Comments on ECE/TRANS/WP.29/GRSG/2019/11

UN Regulation No. 26 (External projection for passenger cars)

#### PROPOSALS GRSG/2019/11

Figure 0 Example of parts distribution

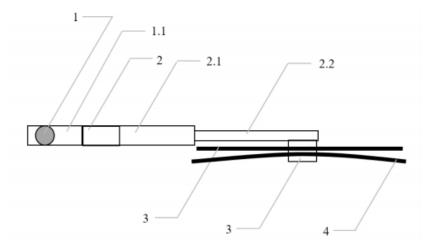
- 6.4.1. The windscreen wiper fittings shall be such that the wiper shaft (number 1 in Figure 0) is furnished with a protective casing (number 1.1 in Figure 0) which has a radius of curvature meeting the requirements of paragraph 5.4. above and an end surface area of not less than 150 mm². The holder (head, main and/or other parts, i.e. numbers 2, 2.1 and 2.2 in Figure 0) are designed with a radius of curvature meeting the requirements of paragraph 5.4. above. In the case of rounded covers, these shall have a minimum projected area of 150 mm² when measured not more than 6.5 mm from the point projecting furthest. These requirements shall also be met by rear window wipers and headlamp wipers.

- 6.4.2. Paragraph 5.4. shall not apply to the wiper blades (number 4 in Figure 0), or to any to supporting members (number 3 in Figure 0) or to the functional hinge between the holder head and the holder. However, these units shall be so made as to have no sharp angles or pointed or cutting parts.
